Grading & Servicing Reviewed

<div>Owner/Applicant</div> <div>DCR/PHOENIX HOMES</div> <div>Telephone # 723-9227</div> <div>Plan # 4M- 1618</div> <div>Project name:PATHWAYS</div> <div>Civic Address:917 OMAGAKI WAY</div> <div>House model: MELBOURNE D</div>	<div></div> <div><div>LOT 268</div><div>SITE/GRADING PLAN</div><div>PATHWAYS PHASE 2</div></div>	INDIVIDUAL LOT GRADING REVIEW SUMMARY FOR SITED HOUSE AS COMPARED WITH OVERALL SUBDIVISION PLAN
<div>Bldg. Ht. _____m</div> <div>Lot coverage _____%</div> <div>Scale 1: 250</div> <div>Sod Area _____m<sup>2</sup></div> <div>Asphalt Area 54.6 _____m<sup>2</sup></div>	NOTE: THIS PLAN IS NOT A SURVEY PLAN OR SUBDIVISION PLAN WITHIN THE MEANING OF PLANNING ACT.	
CHECKED/APPROVED BY: T.L.MAK ENG.

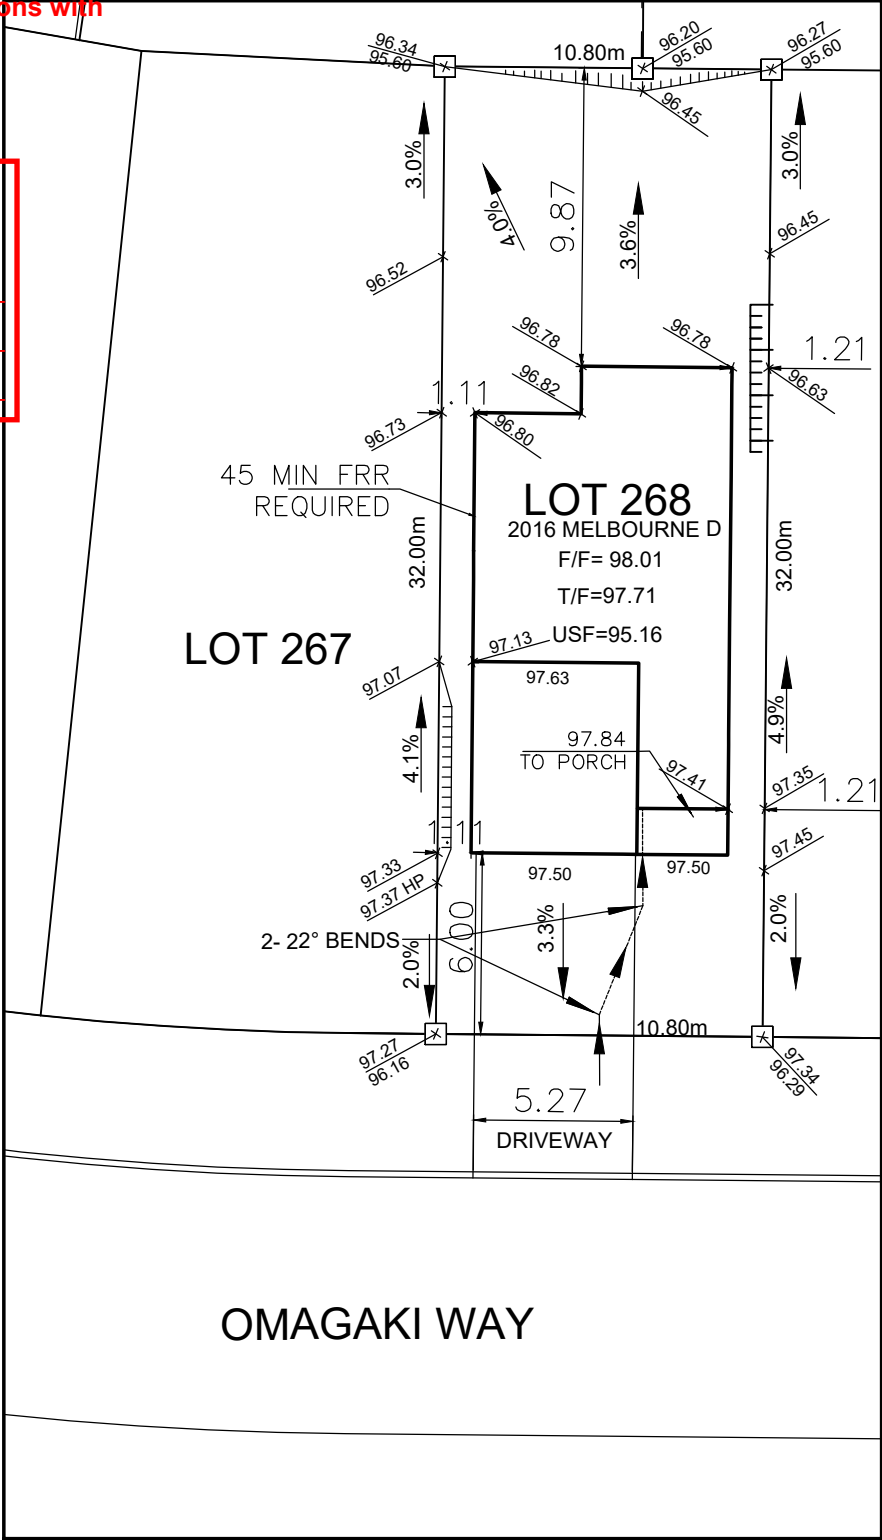
Sleeved services required under retaining walls / footings / garage, and are recommended under porches, decks, and similar structures

No excess drainage to be directed towards adjacent properties  
Existing grading and drainage patterns must not be altered

Match existing elevations with abutting properties

Grading to be 2-7%.  
Grading over 7% to be terraced (max. 3H:1V)

This is a sensitive soils area. All sensitive soil issues related to this application are to be taken up with Building Code Services
